SERVICE INFORMATION

M121.1

MODELS AFFECTED: All CGFV
MODEL NUMBERS: DN5000/3000

RE: Machine Board Microprocessor Installation

Revision .3 Machine Board with new Microprocessor Daughter Board

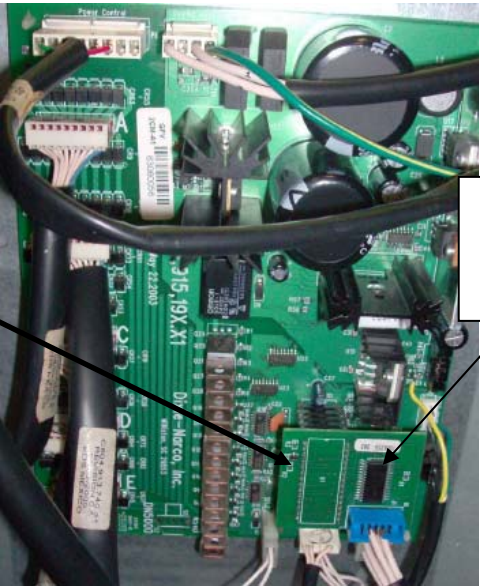
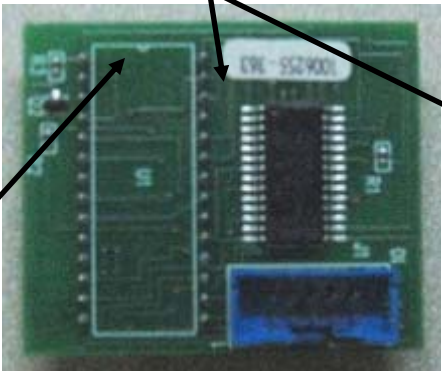
Reason: Original component has reached end of life. New Microprocessor has the same revision software code and plugs in to the existing eprom socket on the Revision .3 Machine Board.

5. Note the alignment notch at one end of the EPROM/Microprocessor Daughter Board and on the control board. The notches must be matched or problems will occur.

Note the
alignment
notch.

4. If you have
 - a. Revision 3 Machine Board install the new EPROM/Microprocessor Daughter Board directly to the U16 socket on the bard. (The legs bend easily. Remove and replace very carefully.)

DN5000/3000 Machine Boards

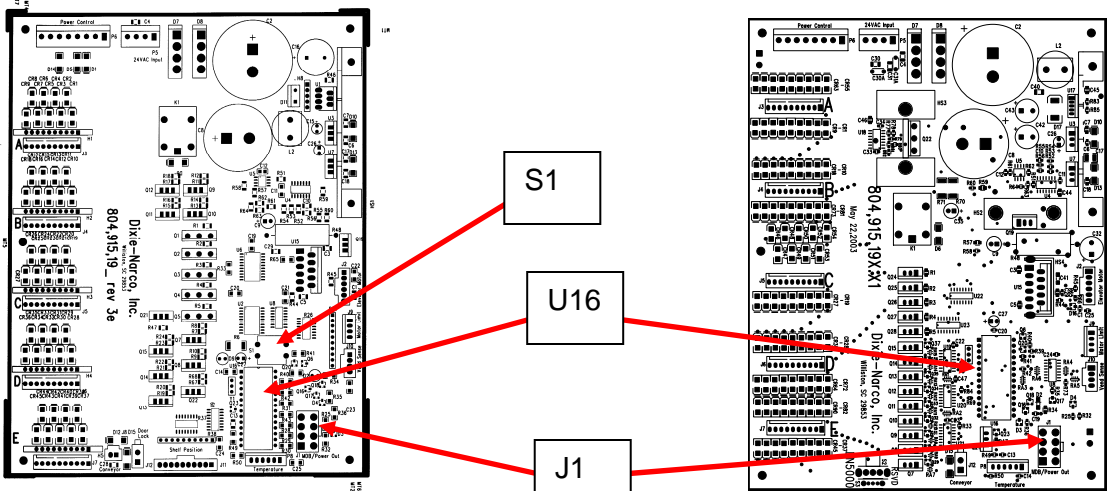
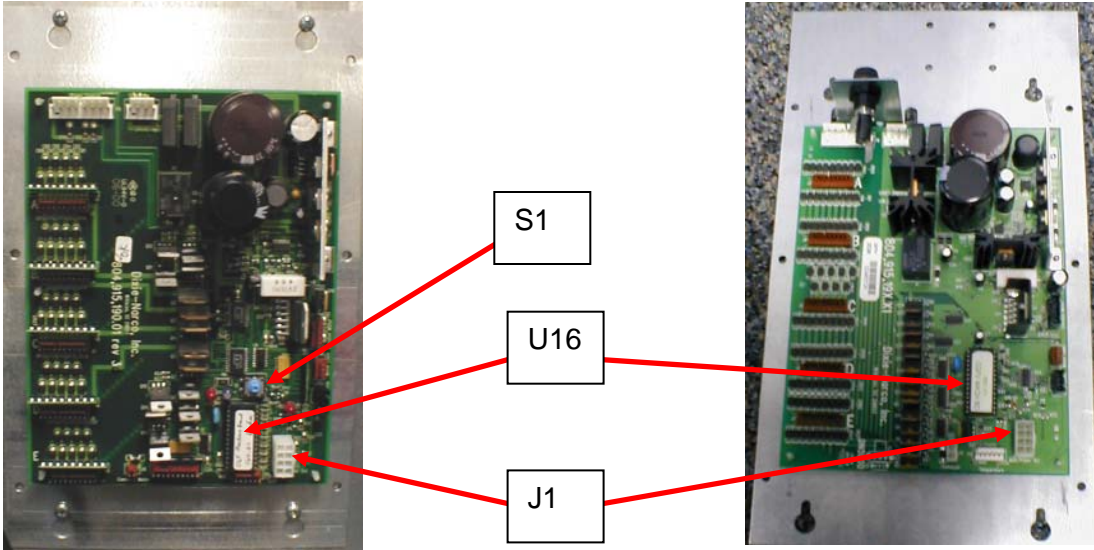
Note: positioning of the microprocessor (eprom) U16 port in relationship with the J1 port for MDB/Power out connector. Also, the revision .3 Machine Board does not have a reset switch. See picture of Machine Board prior to .3 revision port S1 reset switch.

- b. Revision 1 or 2 Machine Board you will need to
 - i. Replace with a Revision 3 Machine Board or
 - ii. Install dual in line sockets to raise the daughter board to allow access to the J1 port for MDB/Power out connector on the Machine Board. This will require either:
